Model: Adonis-P		Date: 31-Oct-99	No.: MG035001
Modified Article: Parts Catalog Correction		Prepared by: K. Takagi	
From: Technical Service Dept., GTS Division			
Reason for Modification:	<input checked="" type="checkbox"/> Parts catalog correction <input type="checkbox"/> To facilitate assembly <input type="checkbox"/> Part standardization	<input type="checkbox"/> Vendor change <input type="checkbox"/> To improve reliability <input type="checkbox"/> Other	<input type="checkbox"/> To meet standards ()

Please make the following corrections to your Adonis-P parts catalog.

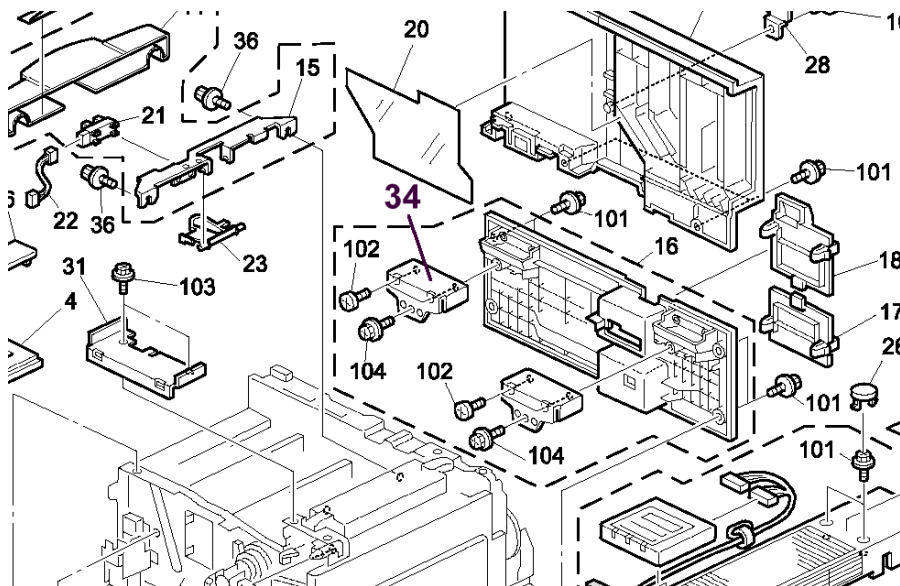
- Adonis-P (G035): Page 10
Add index number 34 as follows

- Adonis-P (G035): Page 25
Add the following part number for index number 1

Index No.	Part No.	Description	Q'ty
1	A2327266	Toner Supply Unit – 115V (RIC)	1

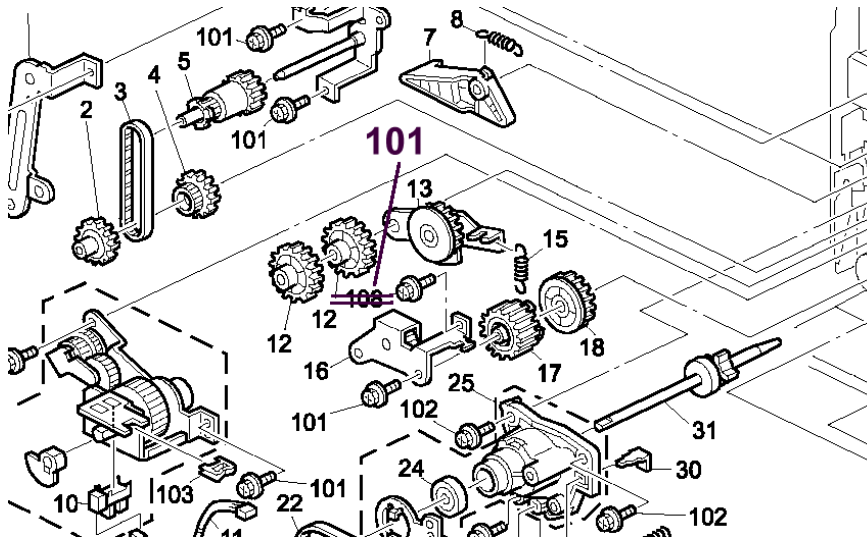
3. Adonis-P (G035): Page 46
Correct index number from 108 to 101

Page 52

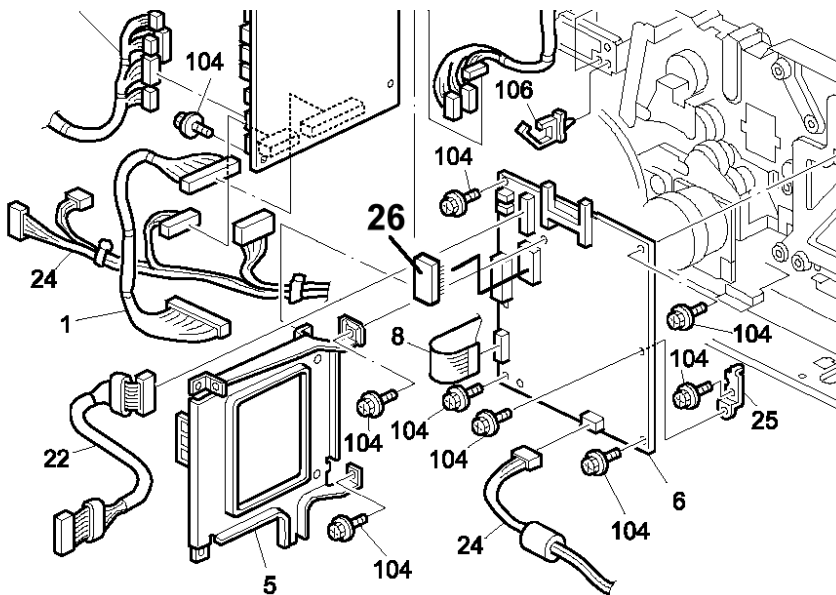
4. Adonis-P (G035): Page 52 and 53
Add NV-RAM (index number 26) and part number as follows

Index No.	Part No.	Description	Q'ty
26	A2849001	NV-RAM - +1000 Counter	1

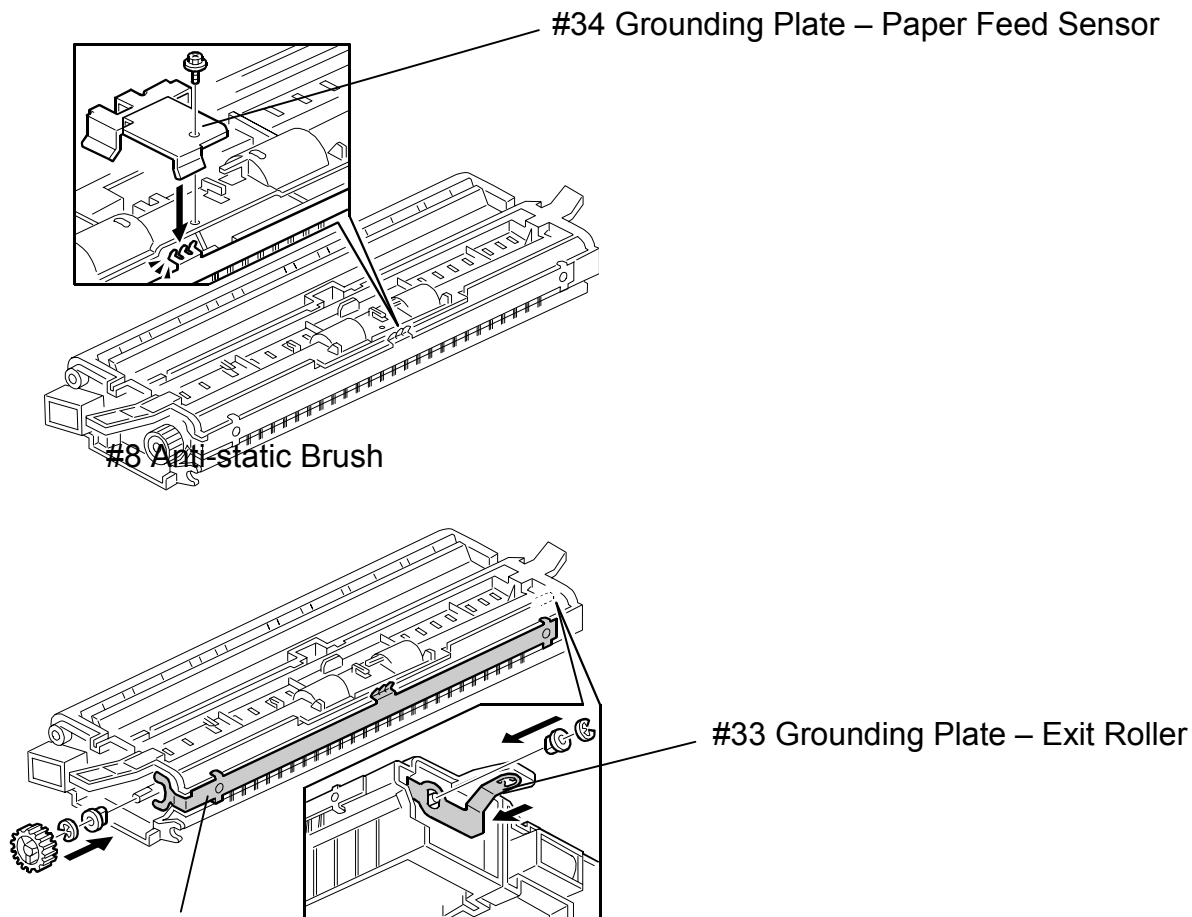
To ensure proper grounding, the shape of the anti-static brush has been changed and grounding plates for the exit and paper feed rollers have been added. Please refer to the illustration below. This modification reduces the occurrence of paper jams caused by static electricity buildup.

Old part number	New part number	Description	Q'ty	Int	Page	Index	Note
AA120089	A2844460	Antistatic Brush	1-1	X/O	39	8	
	A2844462	Grounding Plate – Exit Roller	0-1	-	39	*33	
	A2844463	Grounding Plate – Paper Feed Sensor	0-1	-	39	*34

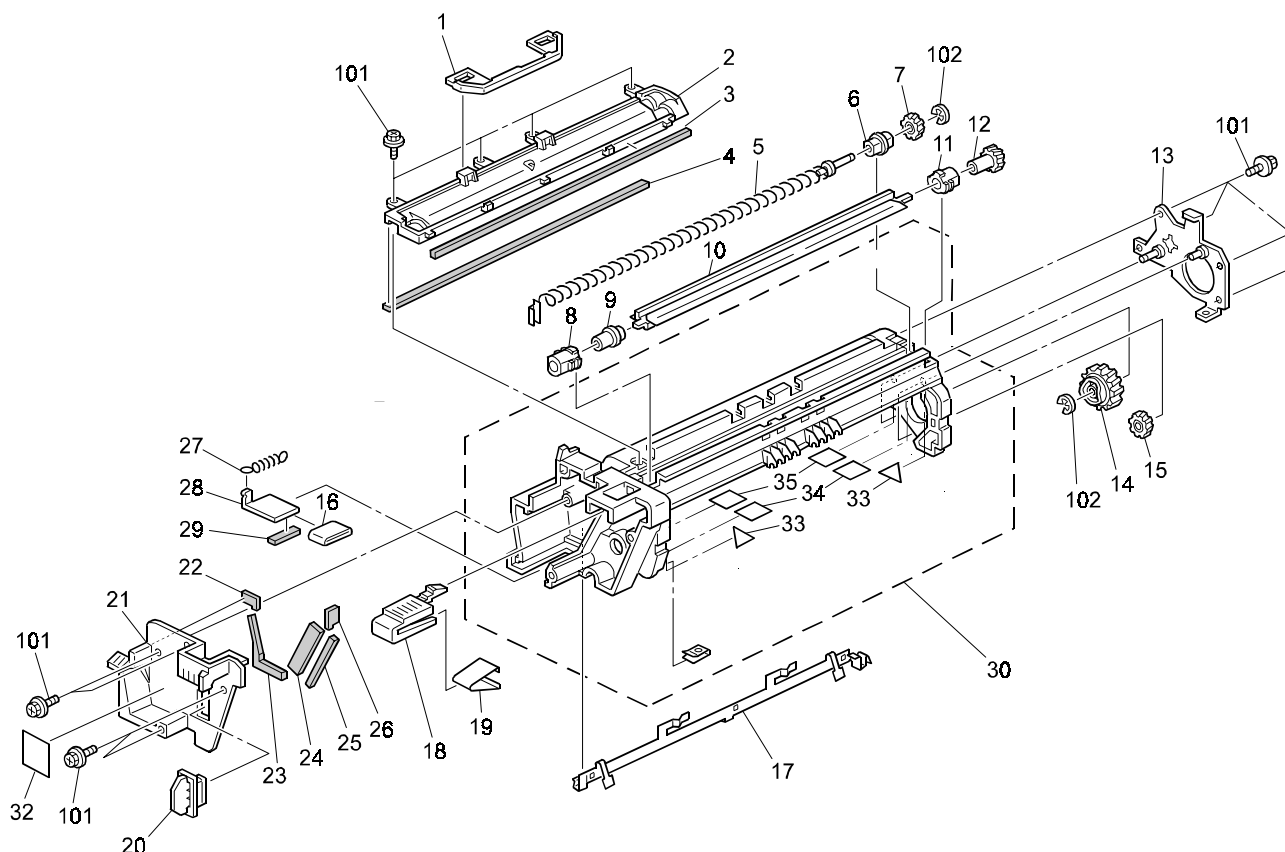
The following part has been registered as a service part.
Please add this to your parts catalog.

Old part number	New part number	Description	Q'ty	Int	Page	Index	Note
-	A2322350	Seal - Entrance	2	-	27	33	
-	A2322399	Seal - Blade 13 x 9.5 x 3	2	-	27	34	
-	A2322348	Seal - Blade 12 x 7 x 3	2	-	27	35

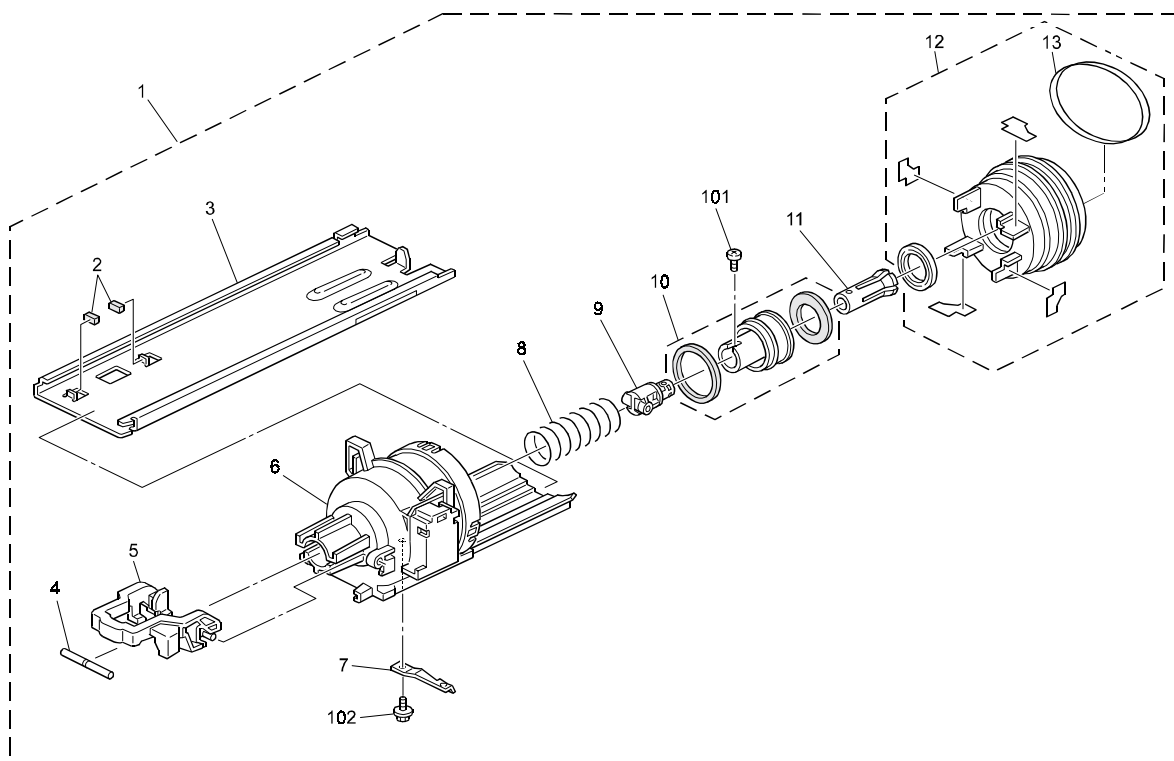
The connection between the toner supply unit and toner bottle is loose, which causes the unit to separate from the bottle when the unit is pulled out. Toner then spills out onto the toner supply unit and sometimes onto the front cover as well.

A seal has been added to the inside of the toner supply unit to minimize the freedom of movement of the toner bottle. This will tighten the hold of the toner supply unit on the bottle, preventing any separation of the bottle from the unit.

Old part number	New part number	Description	Q'ty	Int	Page	Index	Note
-	AA153083	Seal – Toner Supply Unit Cover (RIC NA)	1	-	25	13	
-	AA153084	Seal – Toner Supply Unit Cover (RIC EU and OEM)	1	-	25	13

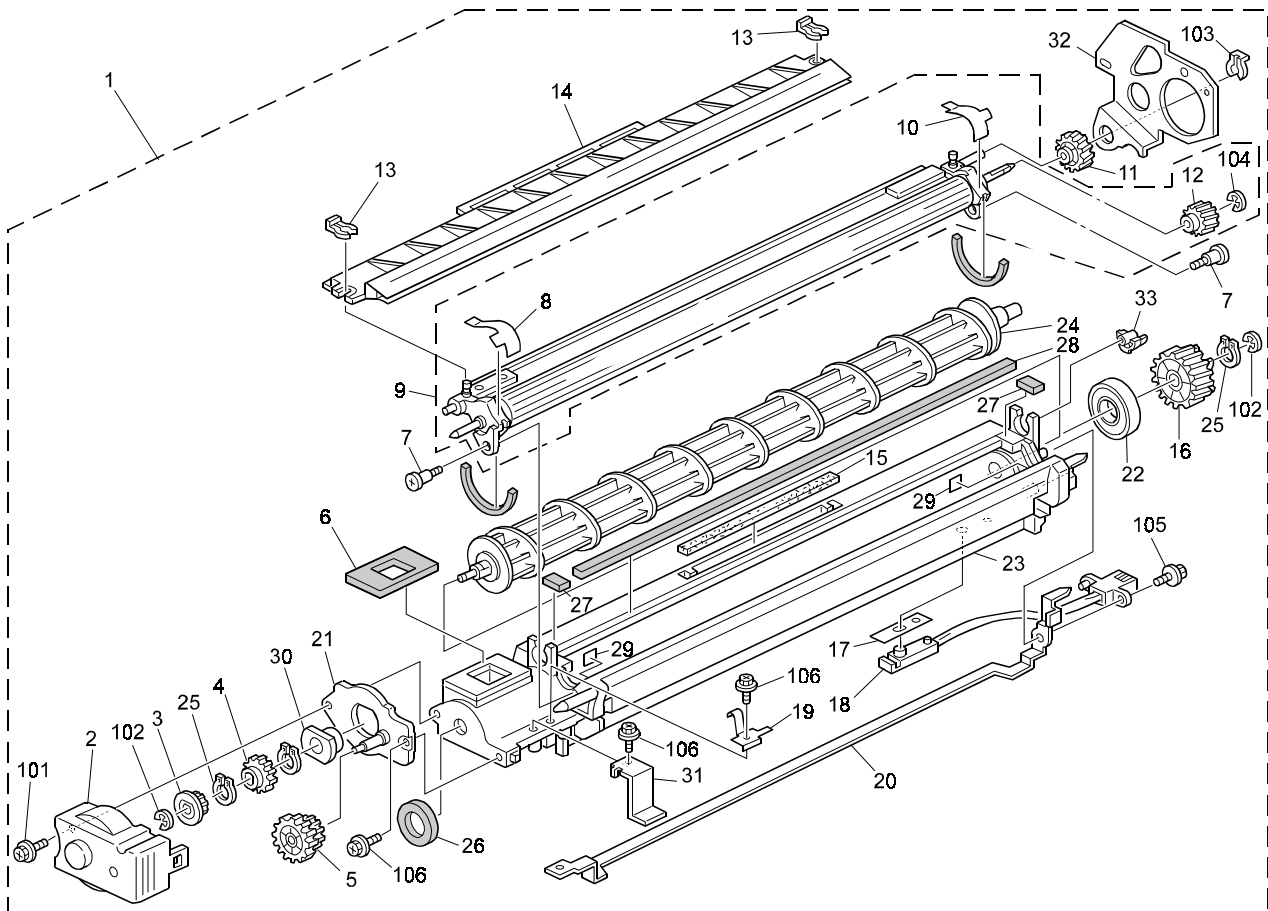
- The original Development Unit (G0353050) is filled with developer before it is shipped from the factory. The developer has a tendency to spill out during transport. However, the factory will not supply this unit without the developer.
- The Development Unit for the NAD (A2327460) can also be used with the Adonis-P if the three components listed below are installed.

When installing these three components in the A2327460 unit, you can either use the components from the original development unit (G0353050) or newly purchased components.

Additional components needed:

1. G0342450 (Index No. 32): Bracket – PCU and Development Unit
2. G0342451 (Index No. 31): Bracket – Development Stay
3. 04503010B (Index No. 106): Tapping Screw – M3x10

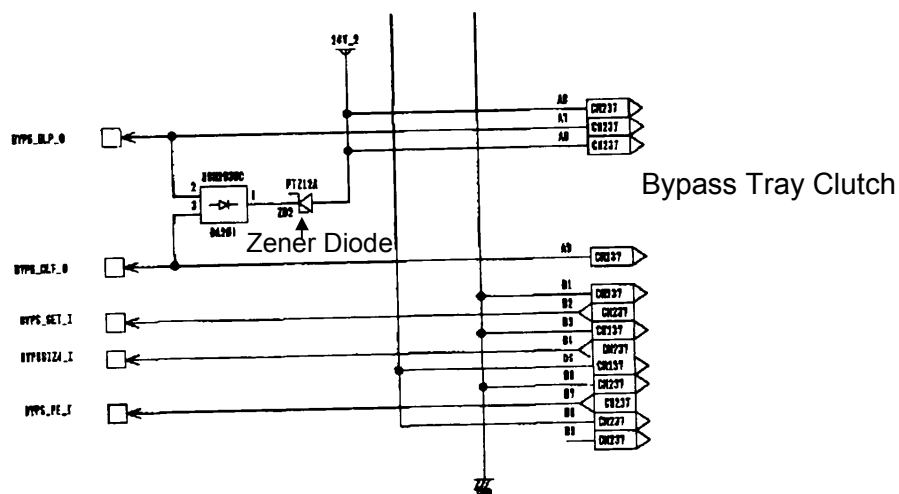
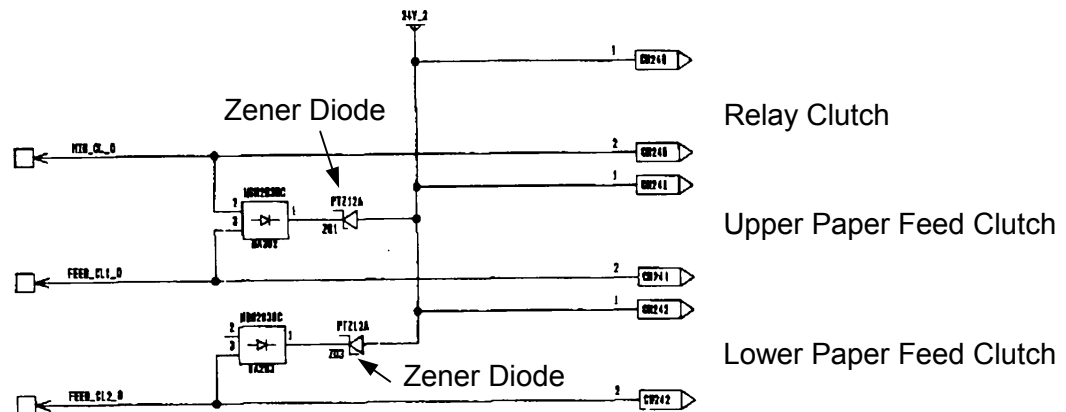
A counter electromotive force flows through the clutch drive circuits and causes the off-timing of the clutch to be delayed. This can result in a paper jam.

A zener diode has been added to the drive circuits of the PFB board for the following clutches, preventing any counter electromotive force from flowing through the circuits:

Old part number	New part number	Description	Q'ty	Int	Page	Index
A2325130	A2325135	PFB Board	1-1	X/O	49	20

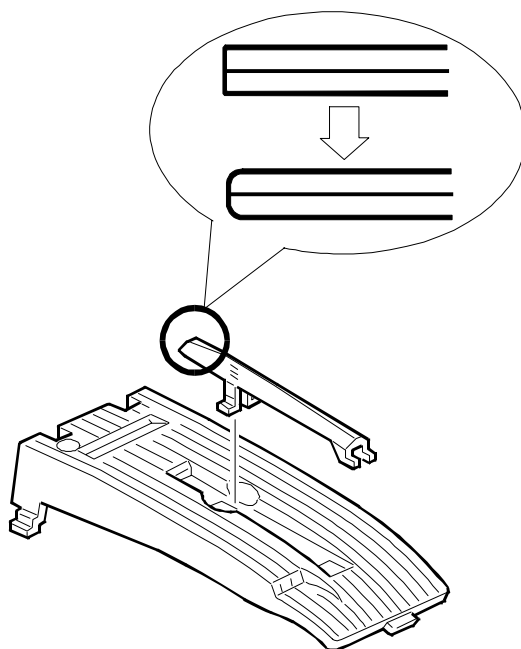
The edge of the copy tray guide has been rounded to ensure that scratches or other minor injuries do not occur.

Old part number	New part number	Description	Q'ty	Int	Page	Index	Note
A2324498	A2844498	Copy Tray Guide	1	X/O	11	2
